Final Environmental Impact Report

Chapters 7 – Response to Comments

ARATINA SOLAR PROJECT by 64NB 8ME LLC (PP20401)

**RE: Response to Comments for Draft Environmental Impact Report – Aratina Solar Project by
64NB 8ME LLC (8Minute Energy) (PP20401) (SCH #2021020513)**

Comment Letter 45: Kometas, Barbara (June 11, 2021)

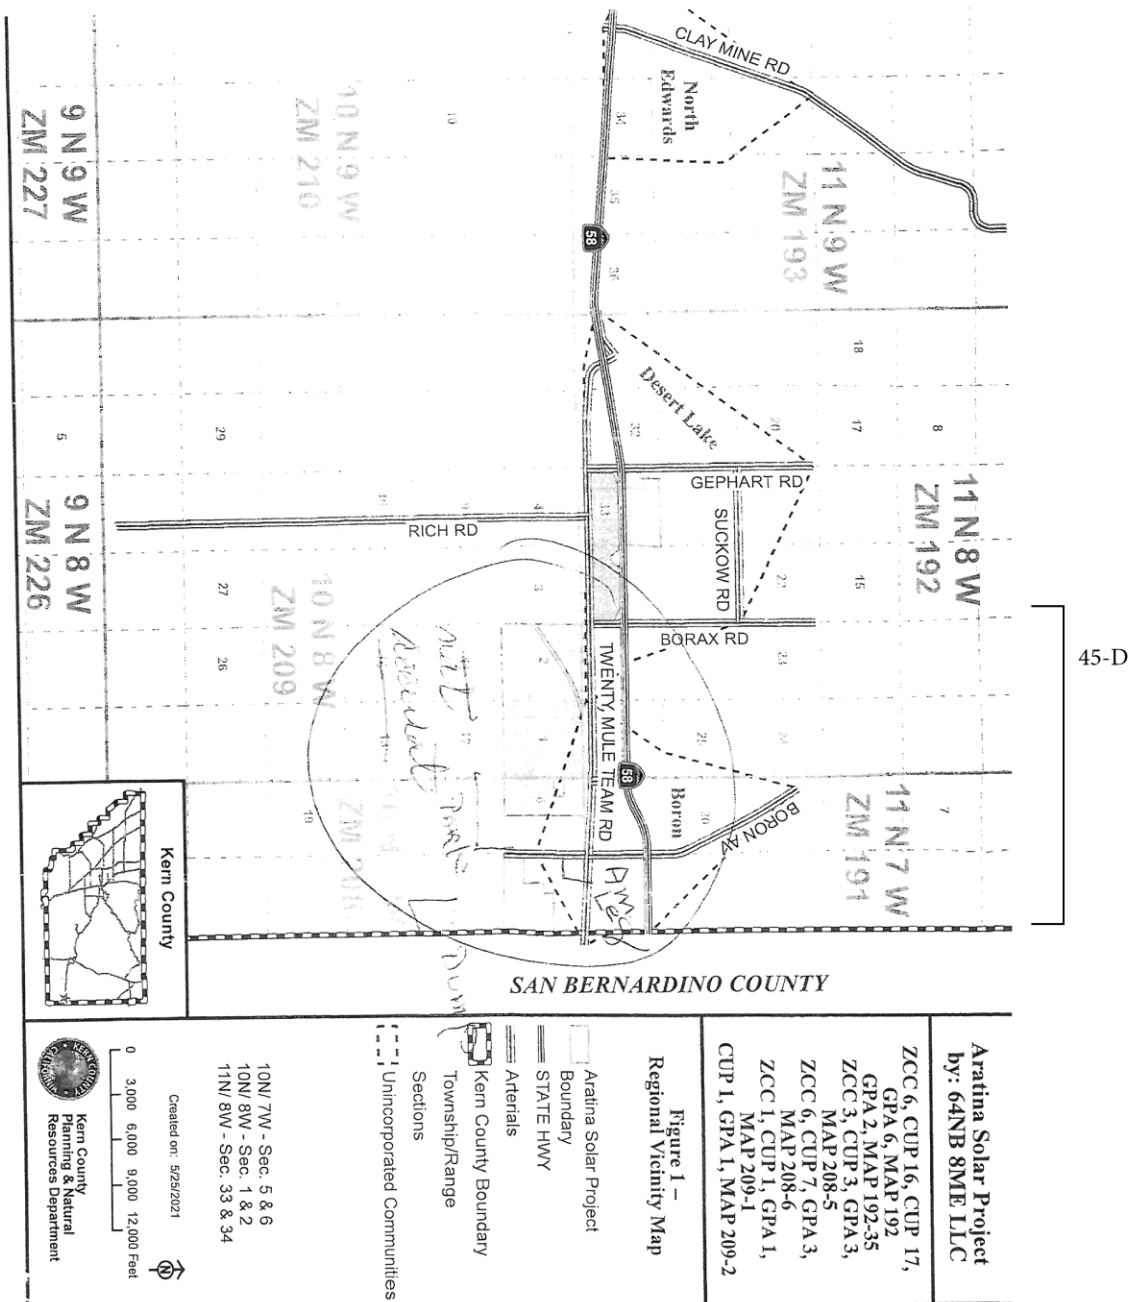
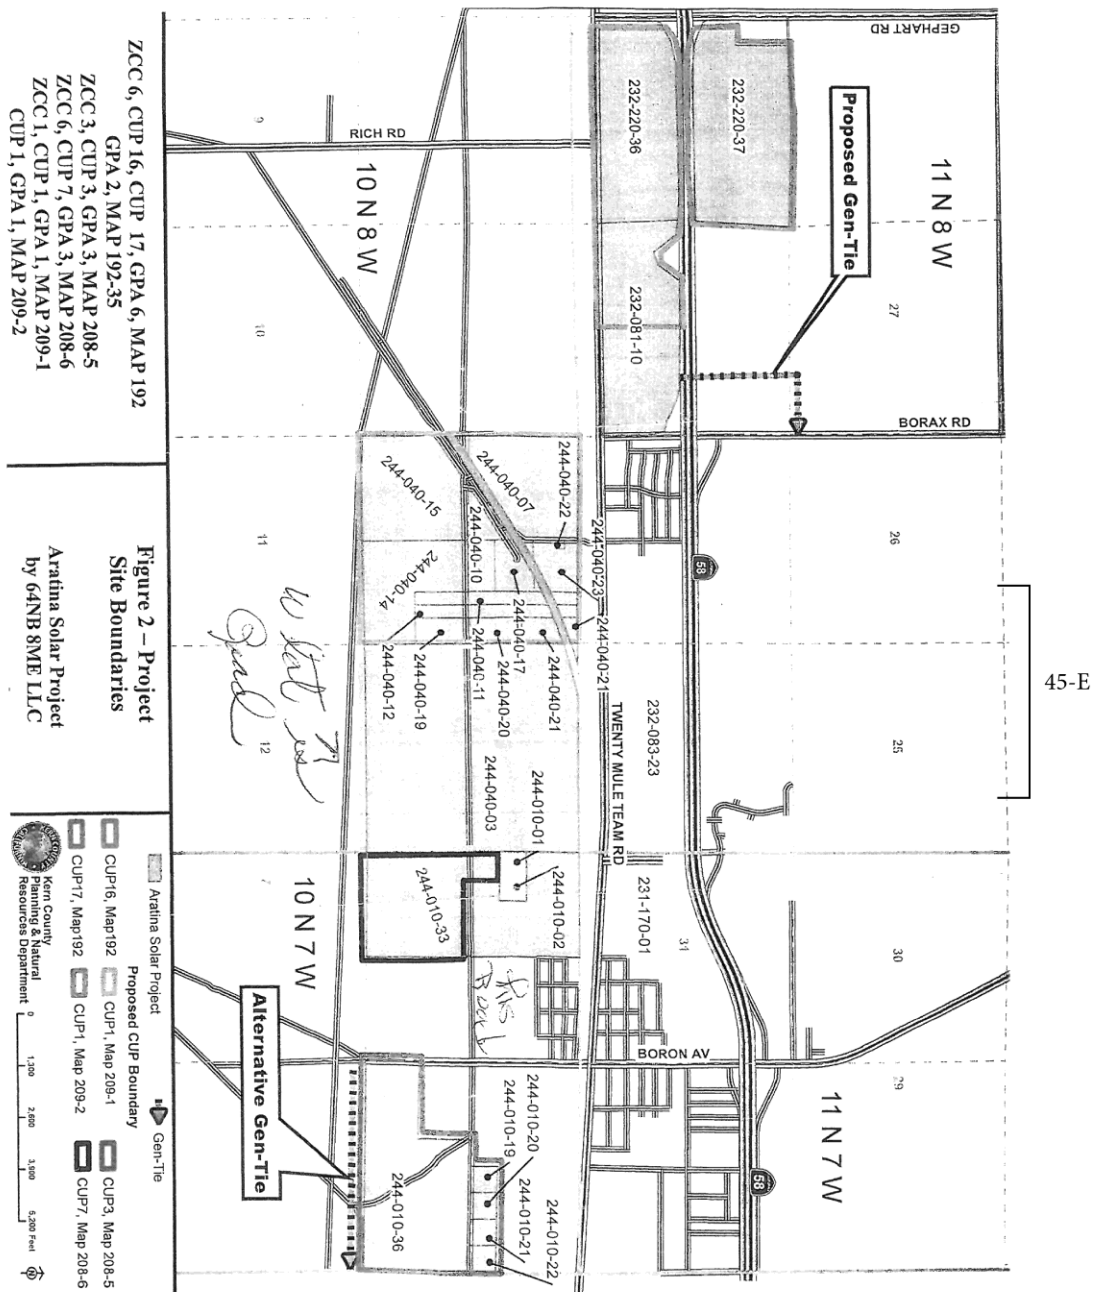
First I must say: The solar plant is a good project. As I study these maps - some of the these dimensions on it do not seem accurate in dimensions. It seems at Bron are and TMT road, sec-2-1-6 are not accurate. Museum, housing area, does this to all be bought by Aratina, it line on Ferguson St is it extending to that housing area? On paper it is a good. The area and is not clear, I have at the time no map of the area where the houses are. This map seems to be not accurate in site # and location. Please have architect draw something more accurate in dimension. Respectfully submitted

45-C: The commenter states the opinion that the area circled on page 2 of the letter (Figure 1, Regional Vicinity Map) is unclear in site number and location and that the area where existing housing is located is not clear. The commenter requests that the applicant provide a map more accurate in dimension.

- 45-D:** The commenter has circled an area on Figure 1, Regional Vicinity Map, taken from the recirculated Initial Study (not the Draft EIR) and indicates that the map is inaccurate. The commenter notes the location of a public park and a dump on the figure.

- 45-E:** The commenter provides a copy of Figure 2, Project Site Boundaries, from the recirculated Initial Study (not the Draft EIR); however, the comment provided is illegible. The commenter appears to be questioning the name of the road to which the arrow is pointing.

The commenter has provided several figures that appear to have been excerpted from the Initial Study recirculated with the Notice of Preparation of an EIR, not from the Draft EIR, and questions the accuracy of certain dimensions and/or that they do not identify certain land uses such as an existing park and dump. Figures 3.10A to 3.10L of the Draft EIR clearly show the proposed project development boundaries for Sites 1 to 5 relative to the location of existing housing in the nearby communities, as well as the specific improvements proposed. The Site Plans (Figures 3.10A to 3.10L of the Draft EIR) also provide dimensions of the proposed improvements. Further, project proximity to any existing sensitive resources in the surrounding area (residential units, schools, etc.) is considered, as appropriate, in Sections 4.3, Air Quality, and 4.12, Noise, among others, in the Draft EIR. No further response to the comments provided is required relative to CEQA.

Refer to Response 45-C. The County acknowledges the comments provided; however, the figure (Figure 1) is accurate in scale and in depicting the project and surrounding roadway system. No revisions to the Draft EIR are necessary in response to this comment and no further response is required.
